DEPARTMENT OF THE AIR FORCE
HEADQUARTERS 49TH WING (ACC)
HOLLOMAN AIR FORCE BASE NEW MEXICO

Holloman AFB is pleased to submit the Responses to NMED Comments on the *Final Nitrate Characterization Study Report Holloman AFB, NM* (NationView, 2014) for your review. The Air Force would appreciate a response prior to December 31, 2015 when the contract for the Nitrate Study expires.

Response to Comments
Final Nitrate Characterization Study Report
Holloman AFB, NM (NationView, January 2014)

Figure 4-11. Monitor Well Locations and Groundwater Flow Direction for Site 4

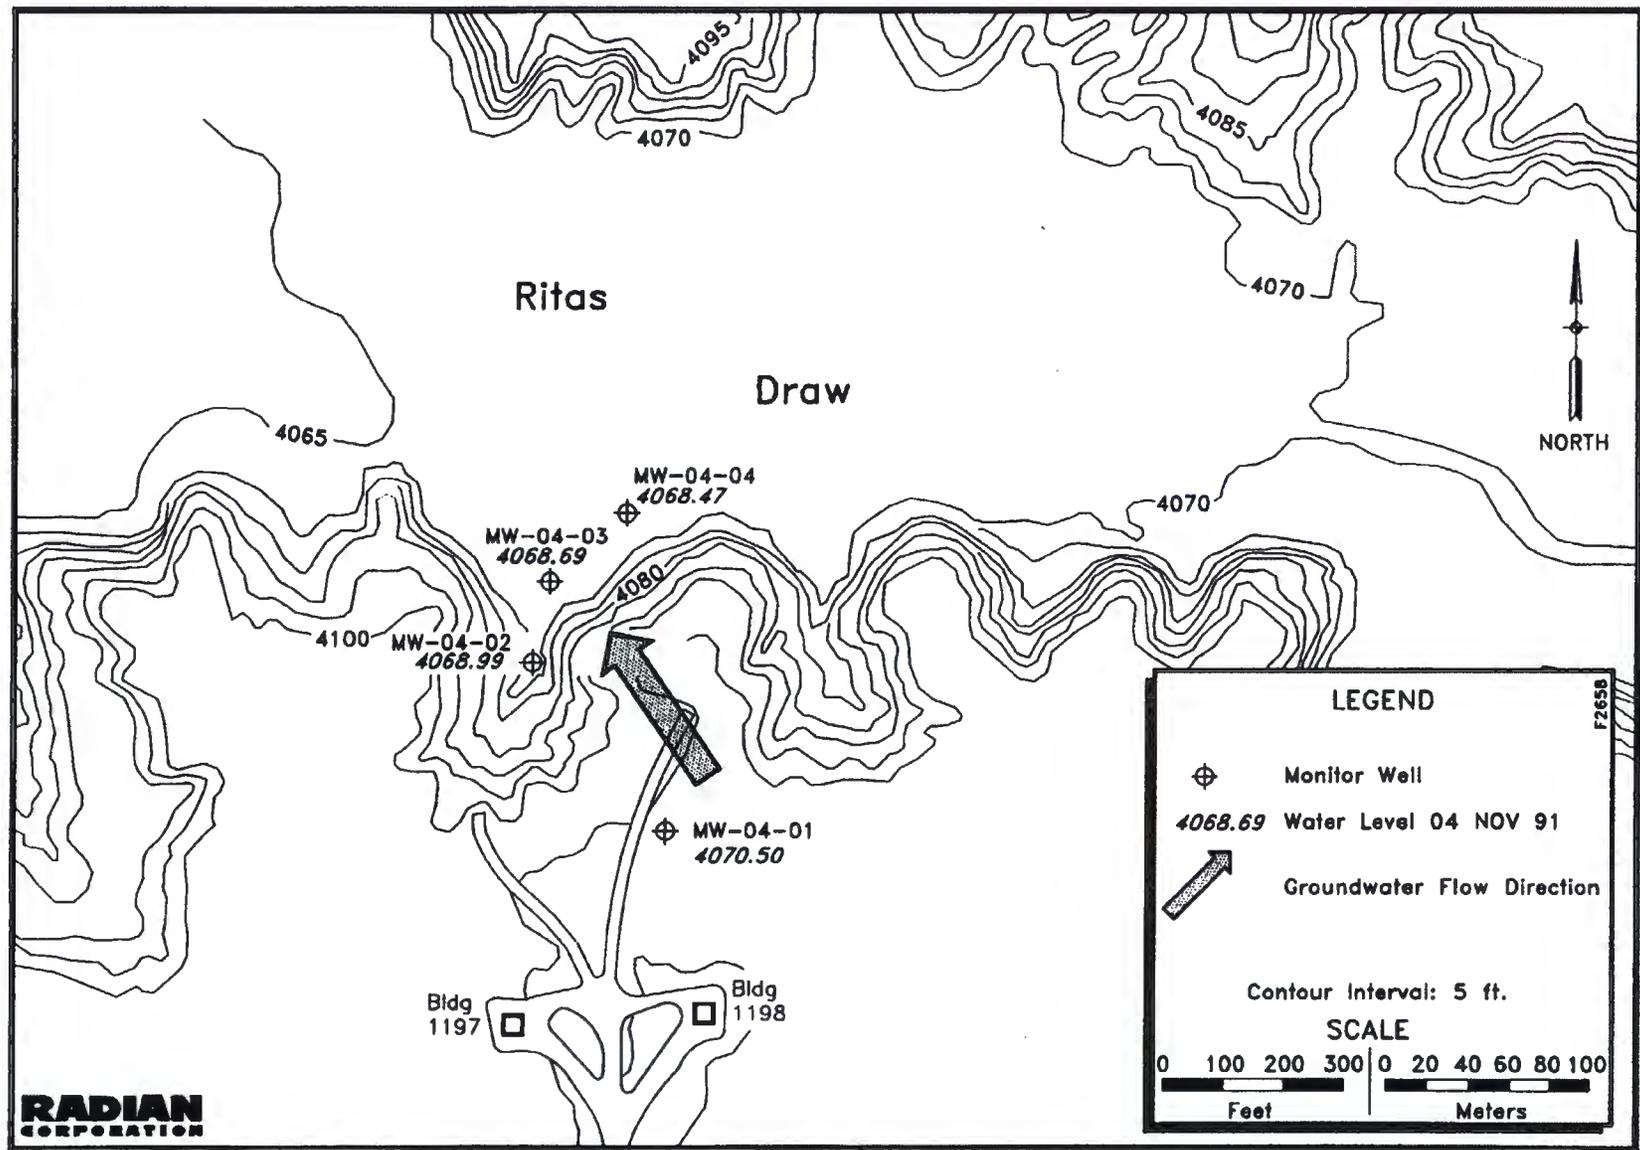
3	Section 2.5.2.1	Figures 2-7 and 2-8	<p>Regarding source area OT-04 (see Figure 2-8), the direction of groundwater flow (shown as north-northeast on the figure) is opposite of that for the regional groundwater as shown on Figure 2-7. Additionally, the water table between wells MW-04-03 and MW-04-04 is essentially flat; whereas, it dips</p>	<p>Site OT-04 and the three monitoring wells (MW-04-02, MW-04-03 and MW-04-04) used to determine the local groundwater flow at the site are located on an escarpment that slopes to the north towards Ritas Draw (a tributary of the Lost River which is a gaining stream along this reach). As a</p>

Comment No.	Section	Page	Comment	Response
Author	Mr. John Kieling, Chief Hazardous Waste Bureau, New Mexico Environment Department		Date of Comments: August 21, 2015	Date of Responses: October 7, 2015
			steeply between wells MW-04-02 and MW-04-03. Furthermore, as shown on Table 2-3 of the Report, the water table elevation at well NSA04-MW01 (not used to construct Figure 2-8) is lower than that at well MW-04-02, suggesting groundwater flow to the south. Due to such unusual or conflicting data, the direction of groundwater flow at site OT-04 must be confirmed via the installation of additional wells, or through resurveying the existing wells and re-measuring the depth to water to check for errors in the reported water table elevations, or both. The Permittee must resurvey the wells at the site to verify the accuracy of the measuring points in order to establish, with reasonable confidence, the direction of groundwater flow at site OT-04. The results of this effort must be included in the revised Report, including any necessary corrections to Figure 2-8.	result the local groundwater flow direction at the site mimics the local topography and flows to the north towards Ritas Draw as shown on Figure 2-8. Furthermore, the OT-04 groundwater flow direction during the Remedial Investigation was also to the north using the same monitoring wells (see attached Figure 4-11, <i>Draft Final RI Report Investigation, Study and Recommendation for 29 Waste Sites Holloman AFB, NM</i> [Radian, 1992]). Note: The historical upgradient monitoring well MW-04-01 was abandoned prior to conducting the Nitrate Characterization Study and was replaced with NSA04-MW01 which is located approximately 1000 ft south of OT-04 and is located on the plateau above Ritas Draw, therefore the water level from this well is in line with the regional southerly groundwater flow direction at Holloman AFB.
